RFP 2020-10-02 HVAC Addendum # 2

Response to questions and Duct Plans Update

VILLAGE OF MIAMI SHORES POLICE DEPARTMENT

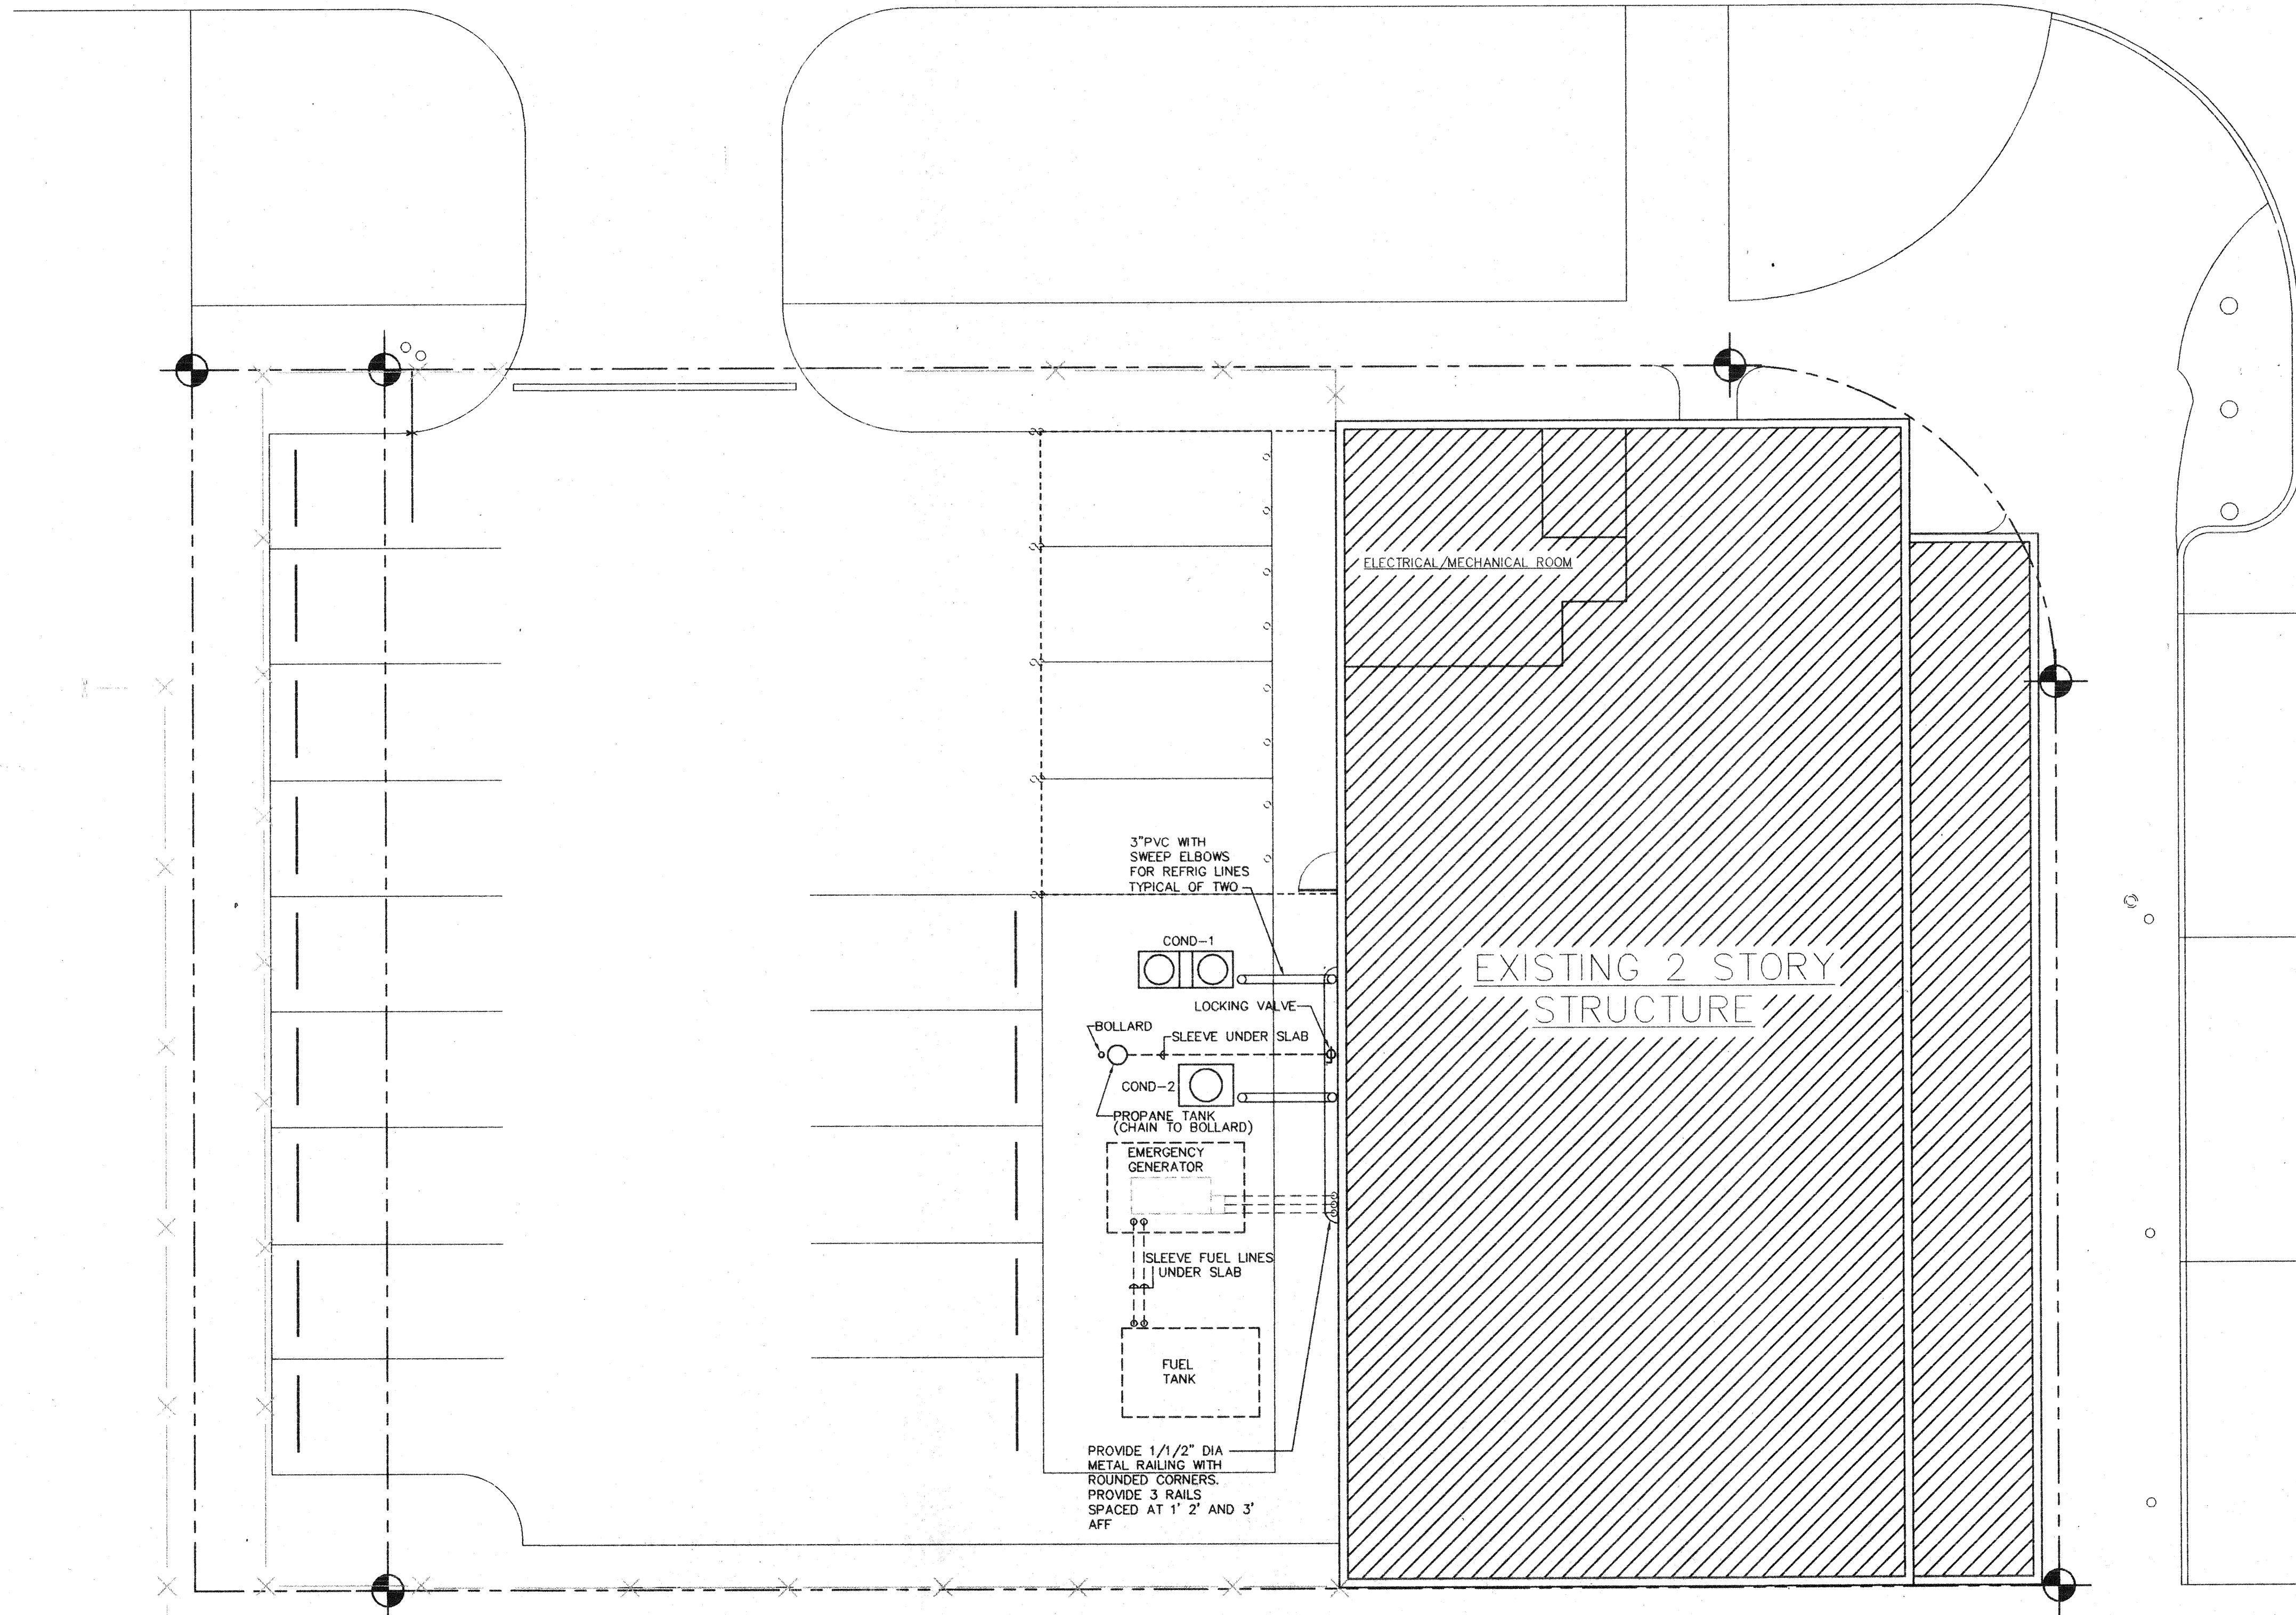
1. Are there any more plans than those posted on the website under addendum 1? There should be at least one more HVAC plan showing equipment capacities as we discovered some discrepancies between the indoor and outdoor existing A/C units. Final capacities – including electrical service- will need to be determined taken into account the new areas to be air conditioned, the information on these additional plans requested and the equipment observed during the walk-thru. –

RESPONSE: Please see the updated HVAC Duct Plans
